ADVISORY
 BULLETIN

No. 2000-01

Official Notification Federal Boat Safety Act Steering Link Rod Attaching Bolt V-6

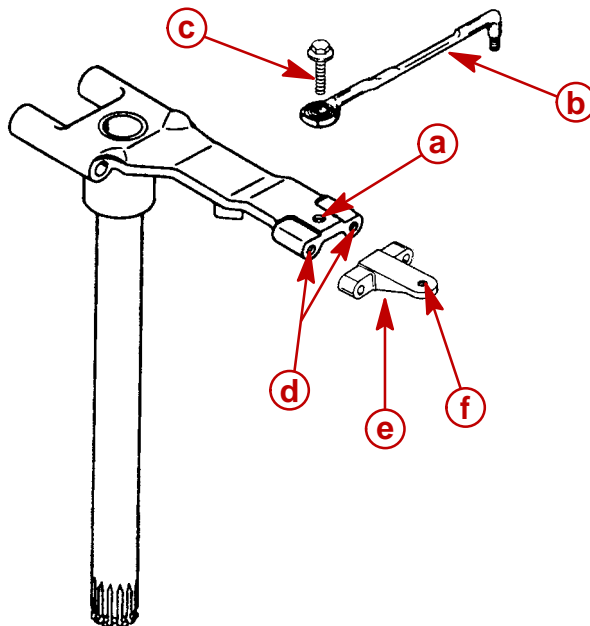
The steering arm top attaching bolt may be at risk for failure. In order to avoid this risk a replacement bolt must be installed. See the "Parts Required" section below in order to identify the correct replacement bolt.

IMPORTANT: Bolts affected include standard steering arm bolt, supplied by Mercury Marine, or any steering arm bolt supplied by OEM/after market (cable or hydraulic) steering system. Only bolts used in steering arm hole (a) require replacement.

- a** - Steering arm top attaching hole, if used, bolt **MUST** be replaced
- b** - Steering link rod
- c** - Attaching bolt if connected to hole (a) **MUST** be replaced
- d** - Front attaching holes, if used, bolts **DO NOT** require replacement
- e** - Extension bracket
- f** - Attaching hole in extension bracket, if used, bolt **DOES NOT** require replacement

Affected engines in the above serial number range using attaching hole **(a)** should have the link rod to steering arm attaching bolt replaced. Engines using OEM/after market steering systems may require various length bolts. Choose the correct bolt length from the following chart. Since the replacement bolts are not offered with shoulders, engines using Teleflex Clevis Kit P/N SA27314P with shoulder bolt, must replace the clevis with Quicksilver Clevis Kit P/N 70599A5, and also use the replacement bolt from the following chart.

SCREW LENGTH "A"	THREAD LENGTH "B"	PART NUMBER
1.250 (31.75mm)	.800 (20.3mm)	10-849838
1.380 (34.92mm)	1.000 (25.4mm)	10-875273-138
1.500 (38.10mm)	1.000 (25.4mm)	10-875273-150
1.625 (41.28mm)	1.000 (25.4mm)	10-875273-162
